Work Order ID 119597

Item Name: Floor Provisions - Energy Attenuating Seat Compatible

DART SERVICE INSTRUCTION

TO AMEND INSTALLATION INSTRUCTIONS IIN-D350-689 REV. B AND INSTRUCTIONS FOR CONTINUED AIRWORTHINESS ICA-D350-689 REV. 1

FIGURE 1: UPDATES TO CROSS SECTIONS F-F AND M-M
 With reference to Figures 5 and 7 of IIN-D350-689
 (Figures 25-5 and 25-7 of ICA-D350-689)

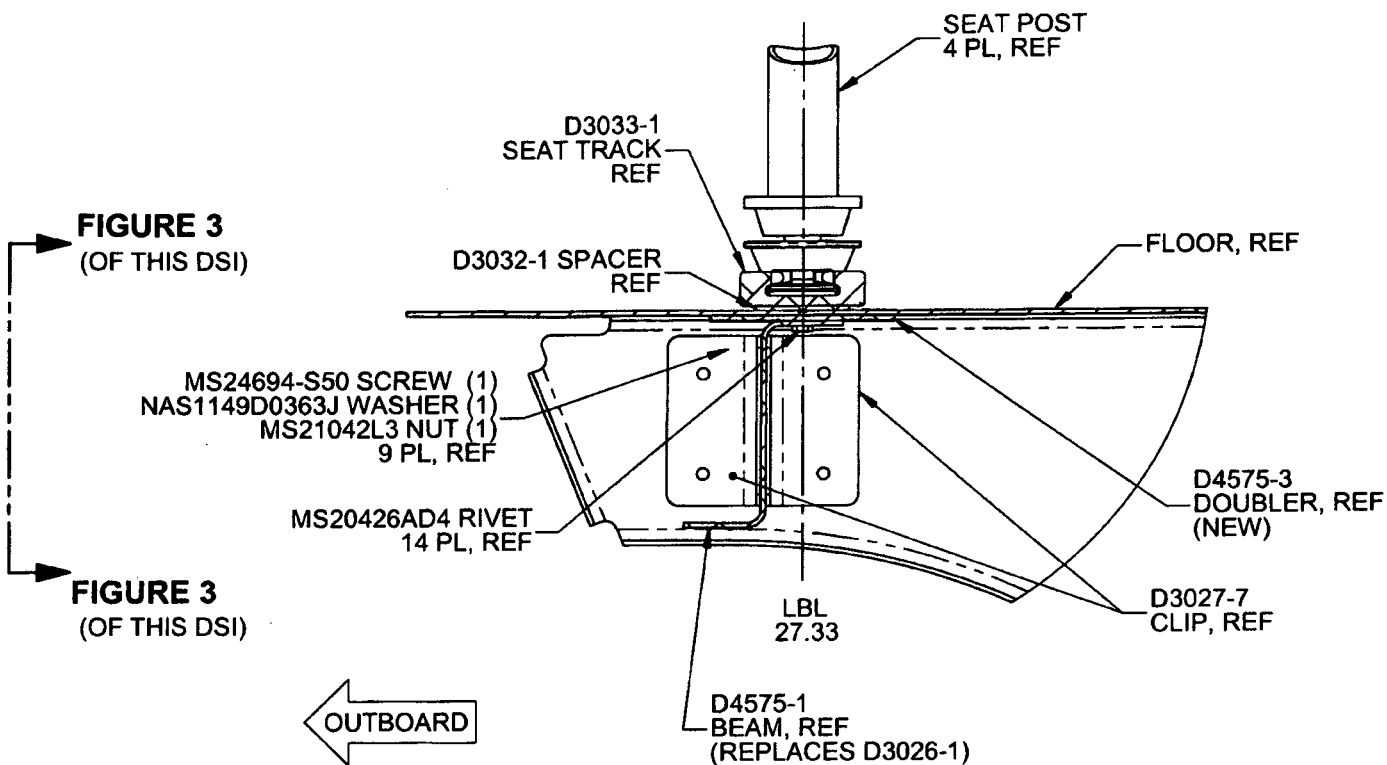
If there is an existing stringer at LBL 27.33, it will need to be removed from that location. Locate D4575-1 Beam, D4575-3 Doubler, and D3032-1 Spacer as shown in Figure 1 of this Service Instruction. Transfer drill existing holes from the aircraft floor to the D4575-1 Beam, D4575-3 Doubler, and D3032-1 Spacer. Ensure 1.0" to 1.5" rivet pitch and add additional holes if required. If there is no existing stringer, locate D4575-1 Beam, D4575-3 Doubler, and D3032-1 Spacer as shown in Figure 1 of this Service Instruction and drill Ø0.128" holes on a 1.0" to 1.5" pitch.

If there is an existing stringer at LBL 27.33, it will need to be removed from that location. Locate D4575-1 Beam and D4575-3 Doubler as shown in Figure 2 of this Service Instruction. Transfer drill existing holes from the aircraft floor to the D4575-1 Beam and D4575-3 Doubler. Ensure 1.0" to 1.5" rivet pitch and add additional holes if required. If there is no existing stringer, locate D4575-1 Beam and D4575-3 Doubler as shown in Figure 1 of this Service Instruction and drill Ø0.128" holes on a 1.0" to 1.5" pitch.

CROSS SECTION VIEW F-F/M-M: From Figures 5 and 7 (IIN-D350-689)
CROSS SECTION VIEW F-F/M-M: From Figures 25-5 and 25-7 (ICA-D350-689)

FIGURE 3: RELIEFS ON D4575-1/-3
(ONLY D4575-1/-3 SHOWN FOR CLARITY)
VIEW LOOKING INBOARD

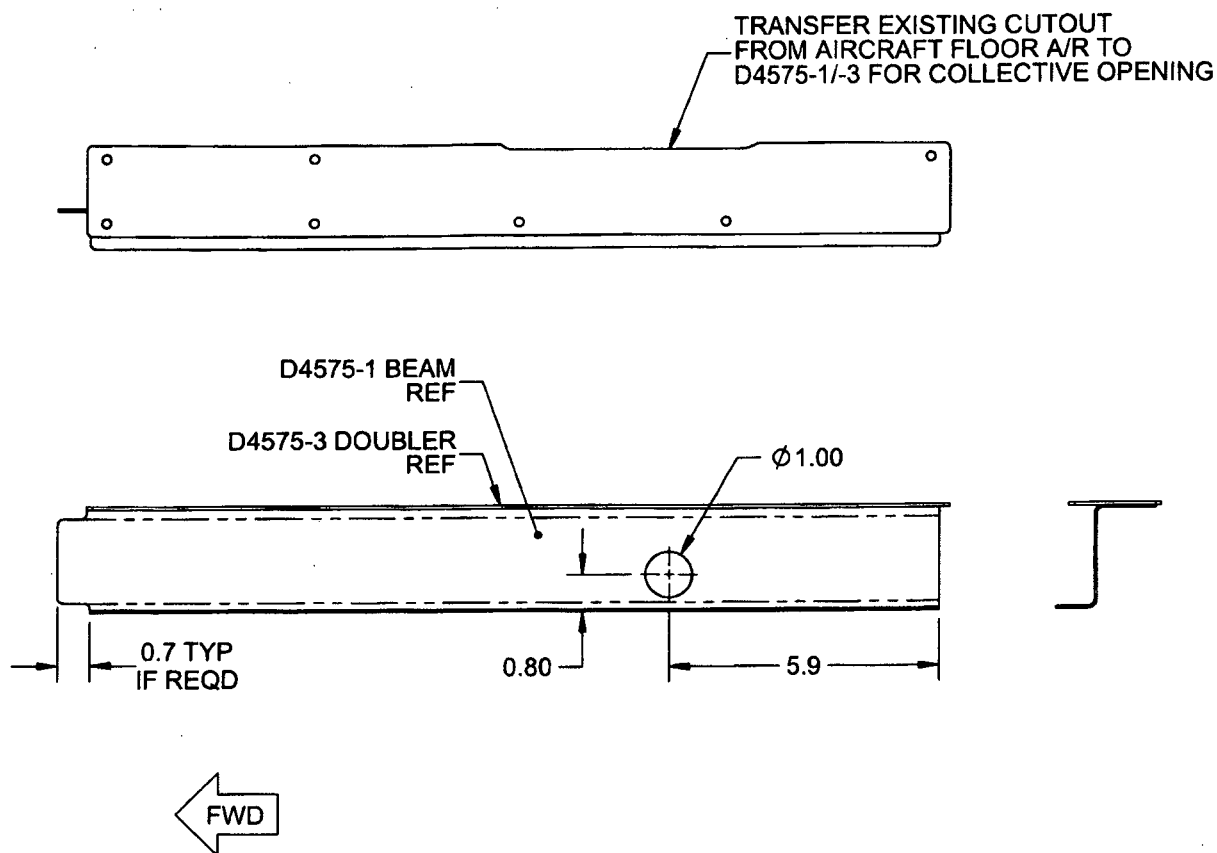
Note: Drill a Ø1.00" (Ø25.4 mm) hole in the D4575-1 Beam to clear extension tube of collective and cutout as required for clearance of collective opening and fwd bulkhead as shown in Figure 3 of this Service Instruction.

Note: Drill a Ø1.00" (Ø25.4 mm) hole in the D4575-1 Beam to clear extension tube of collective and cutout as required for clearance of collective opening and fwd bulkhead as shown in Figure 3 of this Service Instruction.
